## RESPONSES TO COMMENTS ON THE DRAFT ENVIRONMENTAL IMPACT REPORT Volume 3

# Potrero Power Station Mixed-Use Development Project

SAN FRANCISCO PLANNING DEPARTMENT  
CASE NO. 2017-011878ENV  
STATE CLEARINGHOUSE NO. 2017112005

**Figure 4.E-1 (Revised)**  
Transportation Study Area and Study Intersections  
12-21

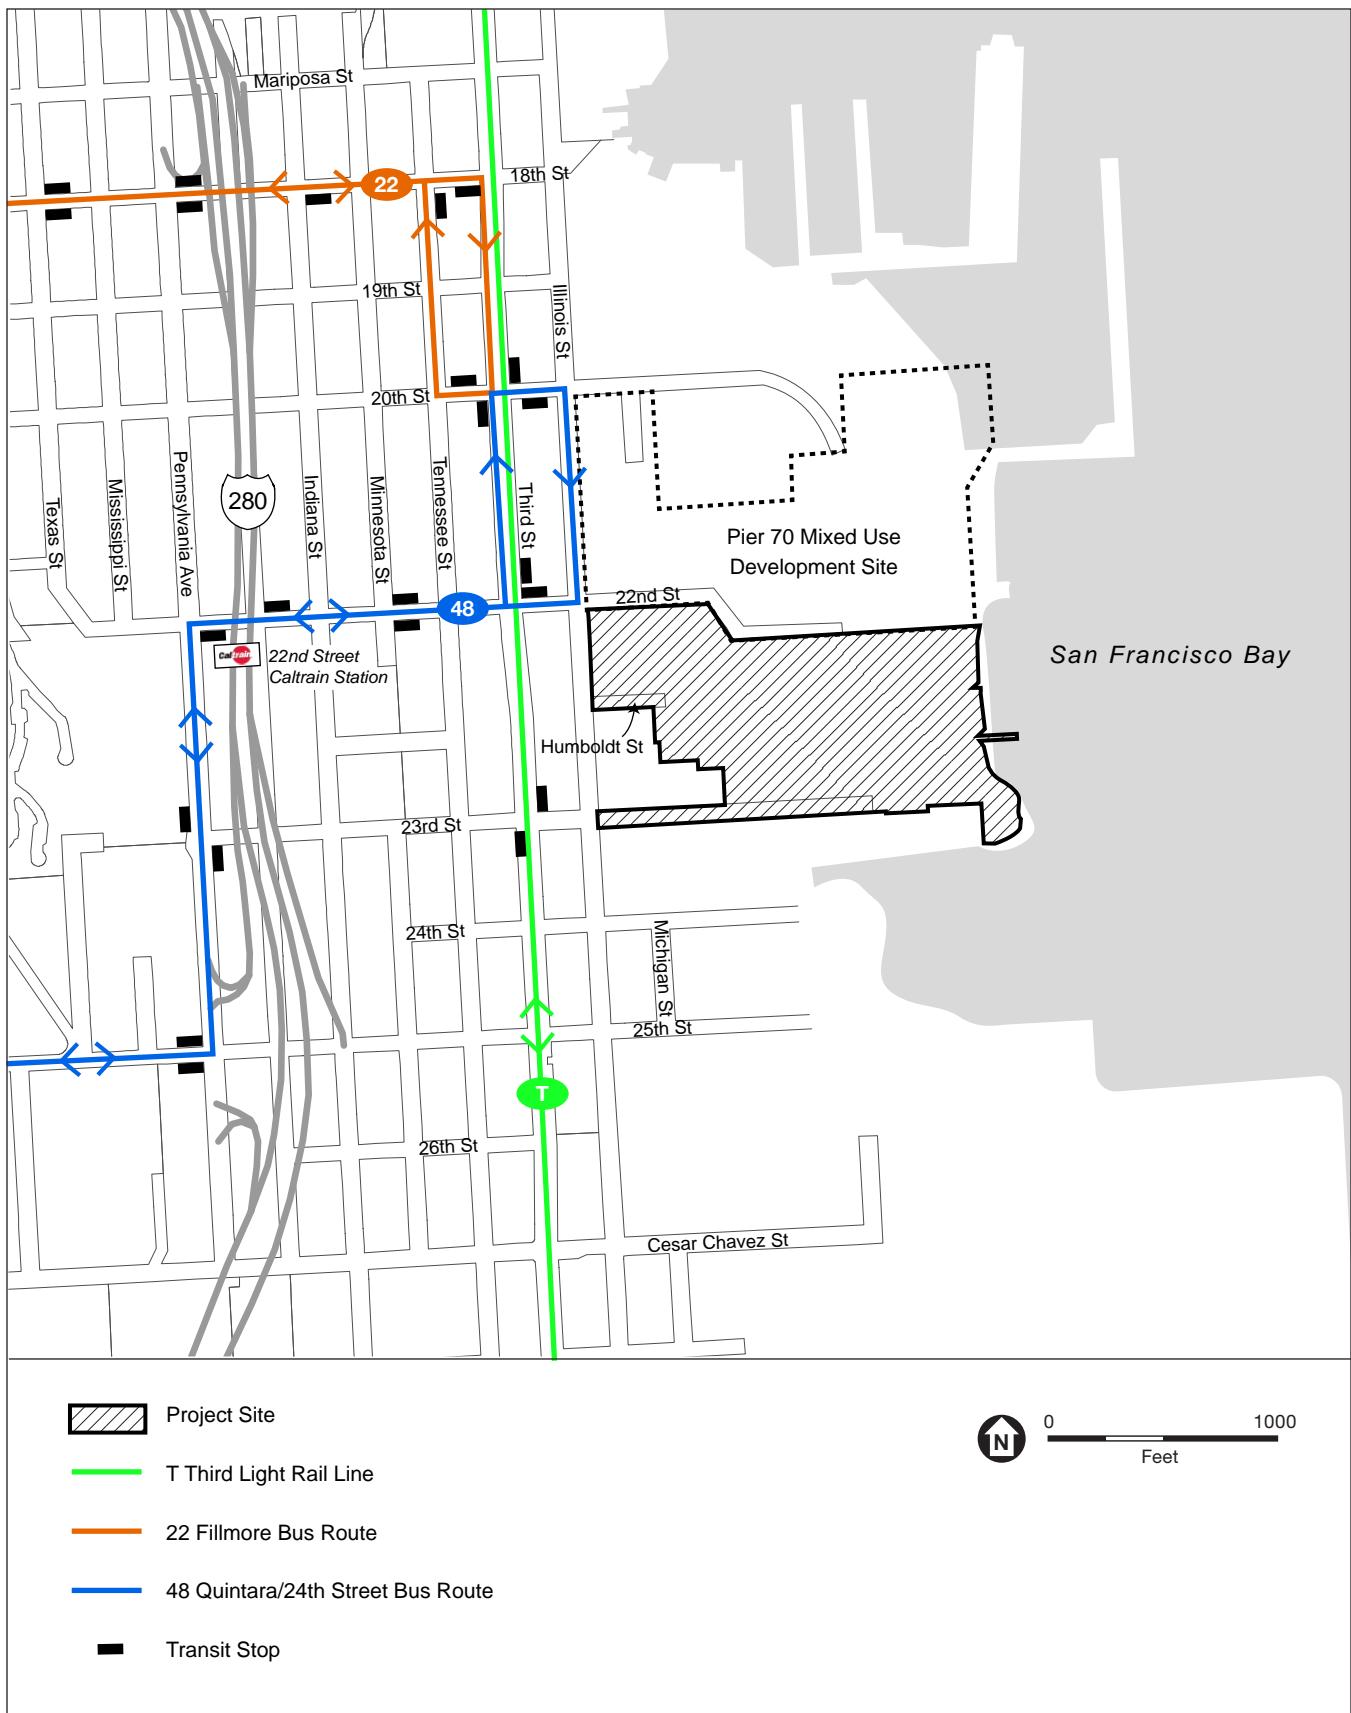
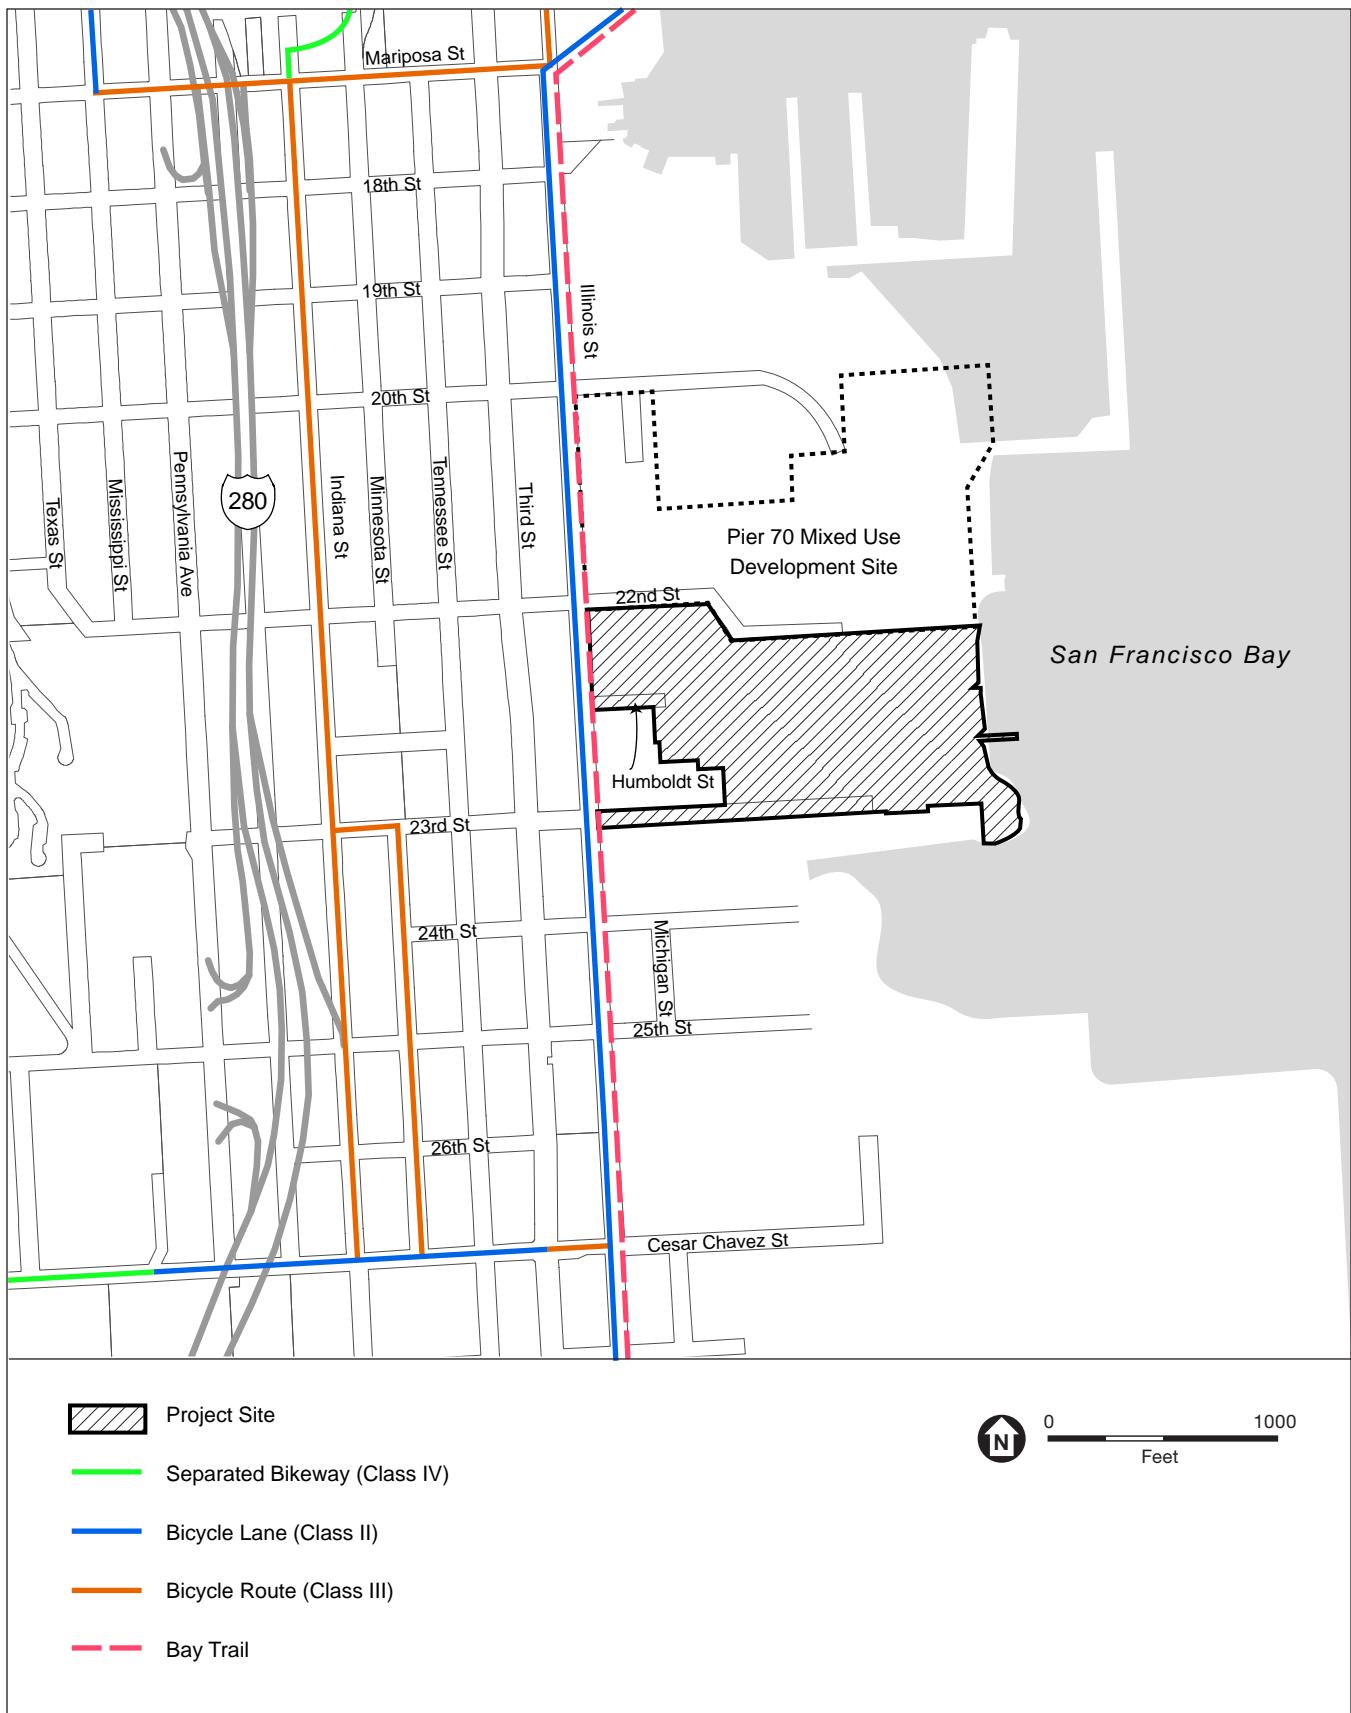
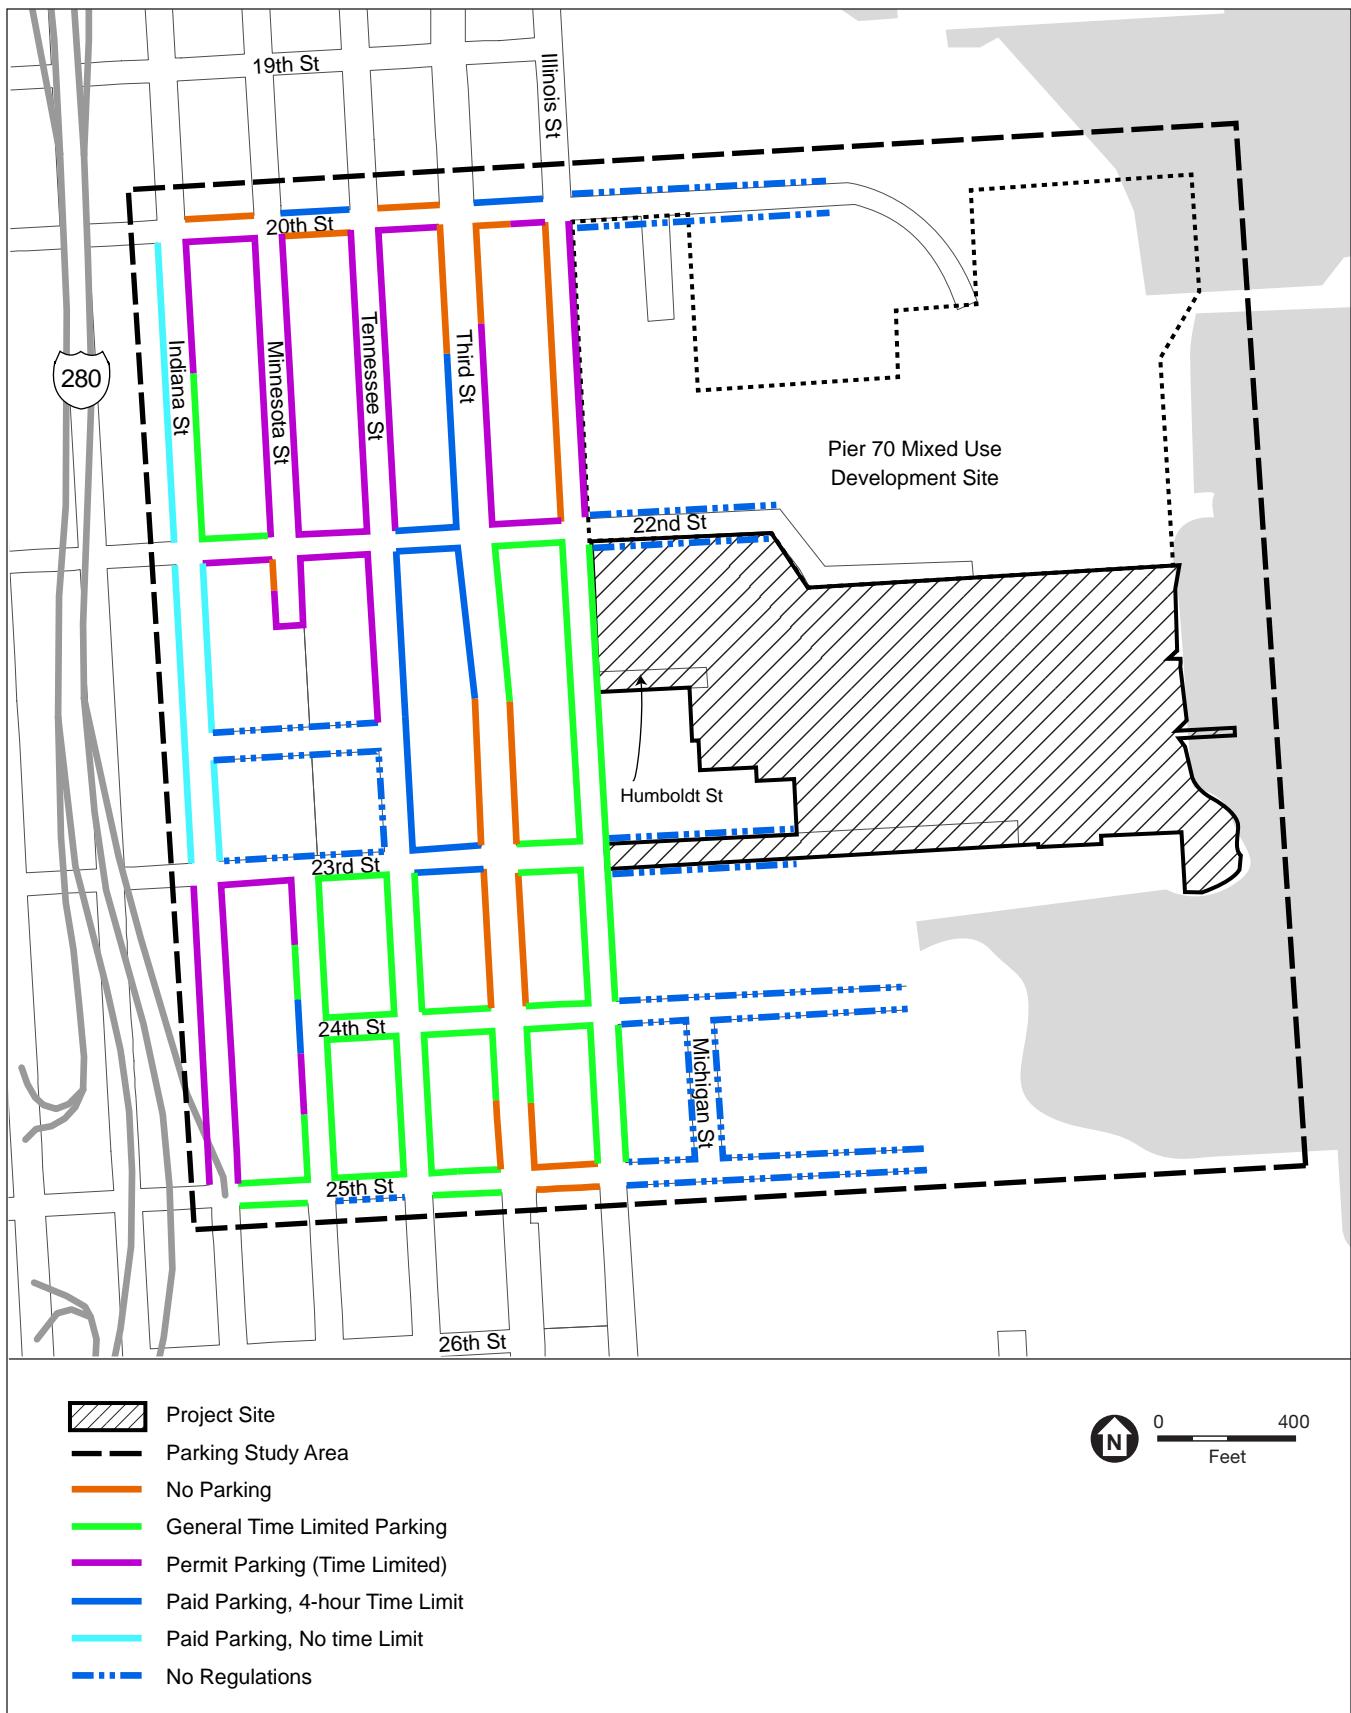
“The project site map in Figure 4.E-1 on page 4.E-2 incorrectly shows the project site as being near I-80. The freeway shown in this Figure should be labeled I-280. The same error is found in the figures following Figure 4.E-1.” (Patricia Maurice, California Department of Transportation, letter attachment, November 16, 2018 [A-Caltrans1-3])

In response to the comment that Figure 4.E-1 through Figure 4.E-4 incorrectly label I-80 as I-280, these figures have been corrected, and the revised figures are included in Chapter 12, Draft EIR Revisions. These revisions do not change the analysis or conclusions presented in the EIR.

In response to a comment by the California Department of Transportation, Figure 4.E-1 through Figure 4.E-4 (EIR pp. 4.E-2, -7, -6, and -20) labels for I-80 are corrected to read as I-280, this is corrected in the revised four figures shown on the following pages:
